1053 SCOMM 28: JOINT GAS PIPELINE COMMITTEE, 1981-82

ALASKA NATURAL GAS TRANSPORTATION SYSTEM

SUBJECT: Questions asked of NWA and Fluor pertaining
to the NWA response and the CCE.

Re: Additional WBEC Questions Concerning CCE

Figure 9.1-1

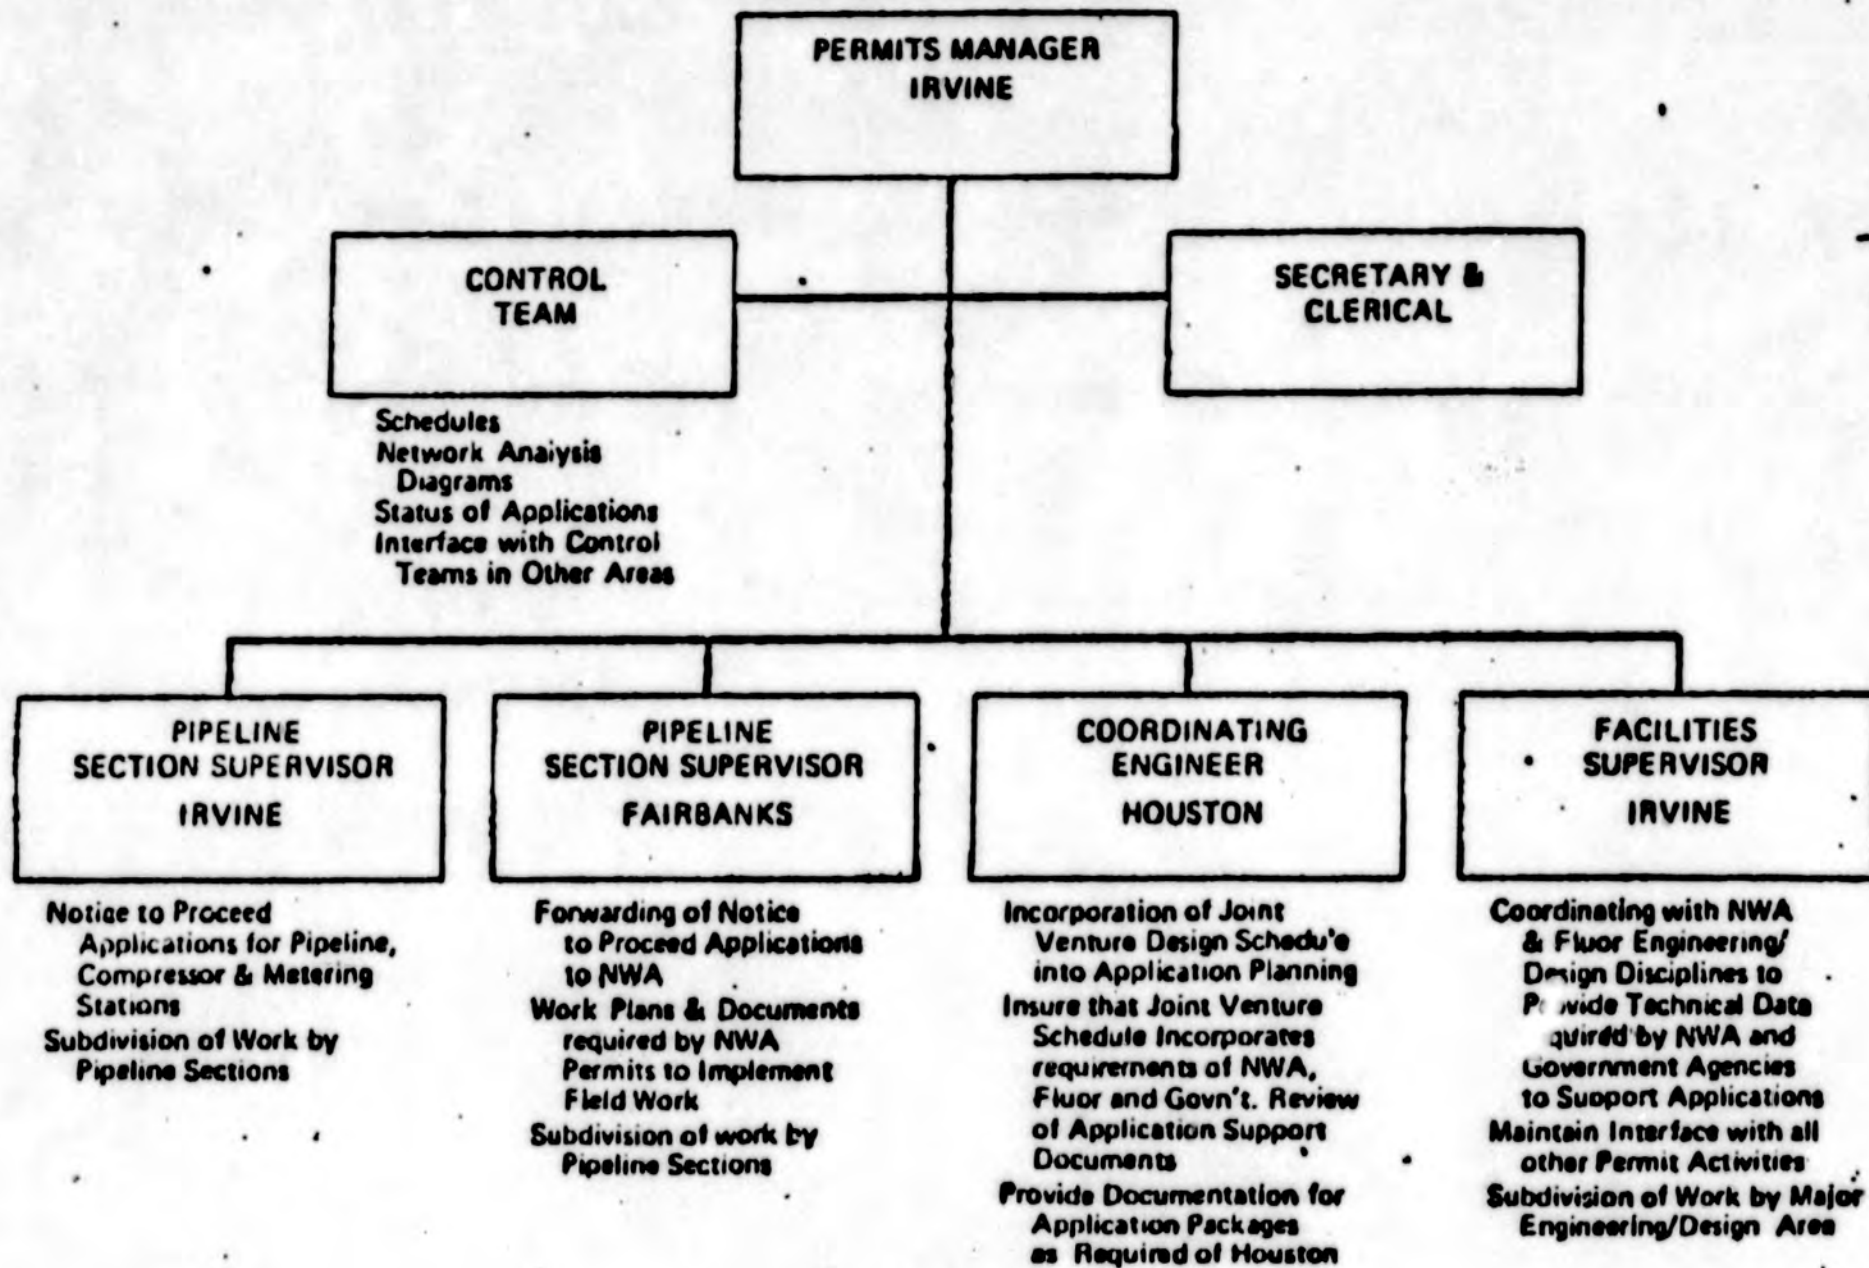
A-1) There are no additional manhours requested for Fairbanks in Trend A264 response page 7-64. The text on response page 7-62 is incorrect and should refer to only Irvine and Houston. The Fairbanks Staffing presented on response page 7-63 is consistent with that in the CCE.
